Recall Bulletin

SB-10057648-9159

SUBJECT: Fuel Fill Pipe Anti-siphon Grid Out of Position

MODELS: 2014 Chevrolet Corvette

REPLACEMENT FUEL FILLER ASSEMBLY P/N 23456467

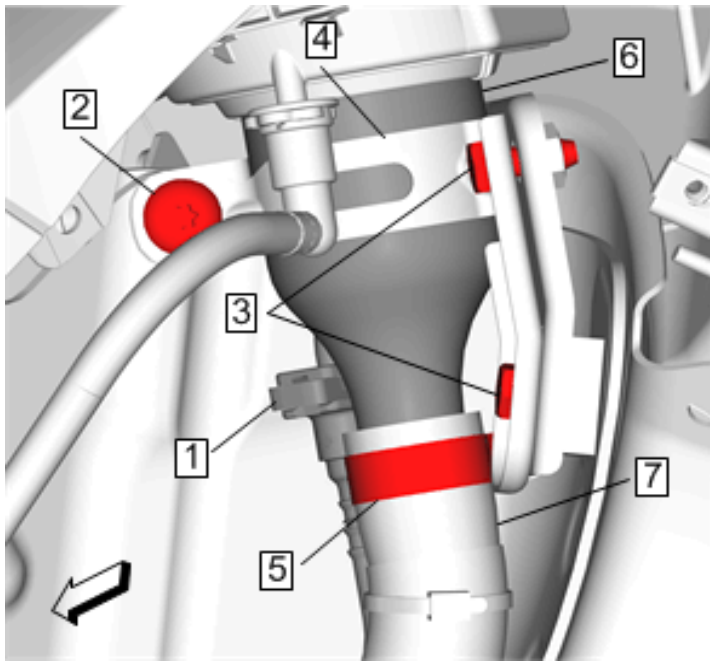
NOTE: Take care when removing the filler hose not to damage the filler pipe seal bead or corrosion resistant paint.

1. Prepare the replacement fuel filler pipe assembly for installation. Remove the hose clamp (2) and hose (3) from the replacement fuel tank filler pipe (1). Discard clamp and hose.
